UNITED STATES PATENT AND TRADEMARK OFFICE

APPLICATION NO.	FILING DATE	FIRST NAMED INVENTOR	ATTORNEY DOCKET NO.	CONFIRMATION NO.
10/594,315	06/27/2007	Lawrence C. Kennedy	032968-0134	2098

DETAILED ACTION

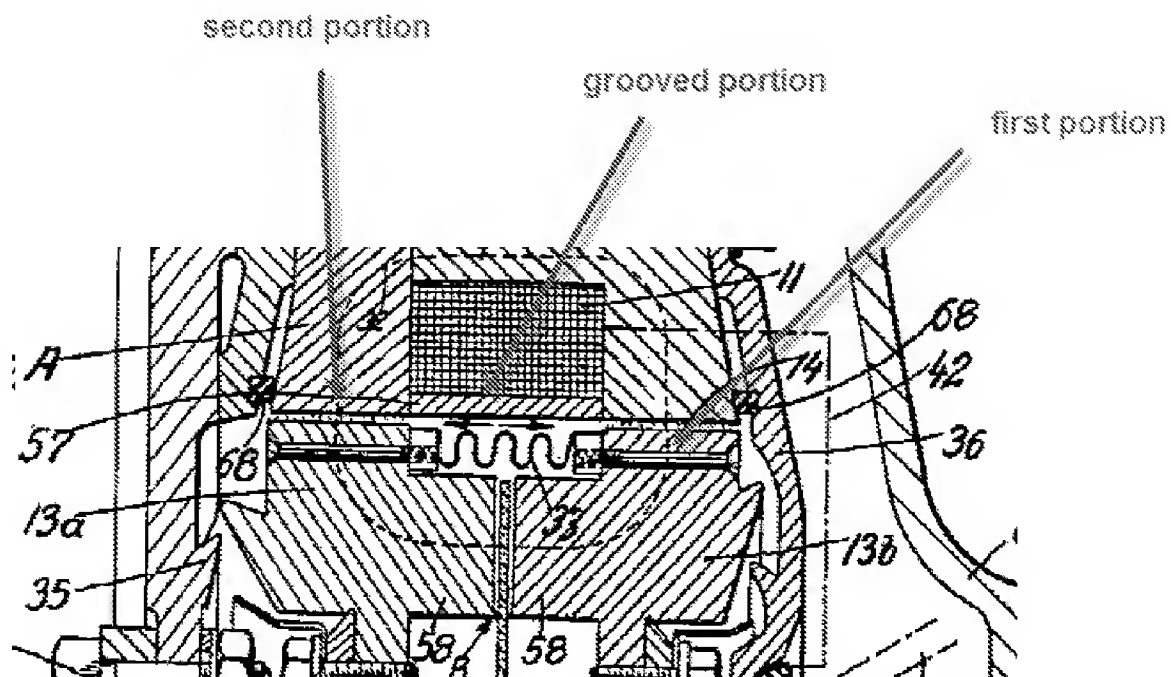
Forster '658 discloses, referring to Fig. 2, a viscous fluid clutch for use in a vehicle (column 1, line 18) comprising:

- a rotor (driven member 13) having a rotor hub (32 or hub members 30a,b) driven by an input shaft (shaft 17) and a rotor surface (facing gap 14) having an end connected to an outer periphery of the rotor hub (via rings 13a,b),

- the rotor surface including: a first portion; a second portion; and a grooved portion disposed between the first and second portions (See Fig. 2 and Fig. below);

- wherein the grooved portion forms a W-shaped profile, wherein a portion of the grooved portion which forms the W-shaped profile is formed by a single piece (springs 33 are formed by a single piece and are in the shape of multiple cursive W's);

- wherein the first and second portions of the rotor each have a thickness sufficiently greater than a thickness of the grooved portion such that a magnetic flux path in the fluid clutch will have a substantial portion of a magnetic field flow around the grooved portion as compared to a portion of the magnetic field flow that flows through the grooved portion. (See Fig. 2, dotted line, see also column 4, lines 71-72)

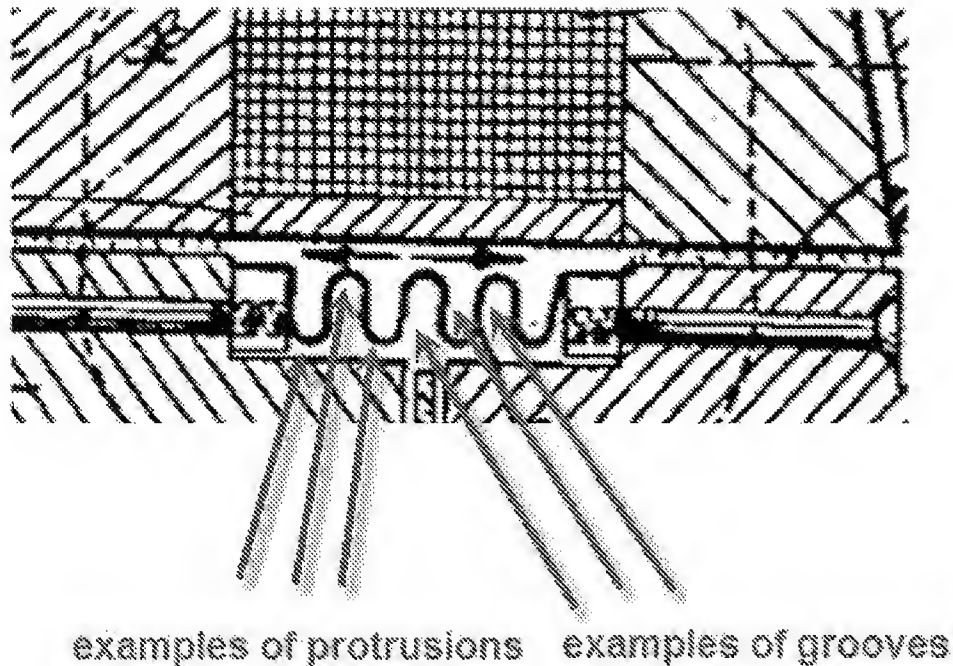
- an input shaft (shaft 17);
- a coil assembly (electrical coil 11) for generating a magnetic field;
- a housing comprising a stator (annular member 12); and
- a rotor (driven member 13) disposed in the housing;
- wherein the rotor includes a radially extending hub (32 or 30a,b) driven by the input shaft and an annular rotor ring (13a,b) connected to the hub; and
- wherein the rotor ring includes a first portion, a second portion, and a portion of reduced thickness (see Fig. 2 and figure below) disposed between the first and second portions to prevent a shunt in the magnetic field,
- wherein the rotor includes a grooved portion (springs 33) which forms a W-shaped profile at the portion of reduced thickness, wherein the grooved portion which forms the W-shaped profile is formed by a single piece.

As to **claims 4 and 5**, Forster '658 discloses: wherein the portion of reduced thickness is formed to include grooves and protrusions (see figure below), which form the W shaped profile.
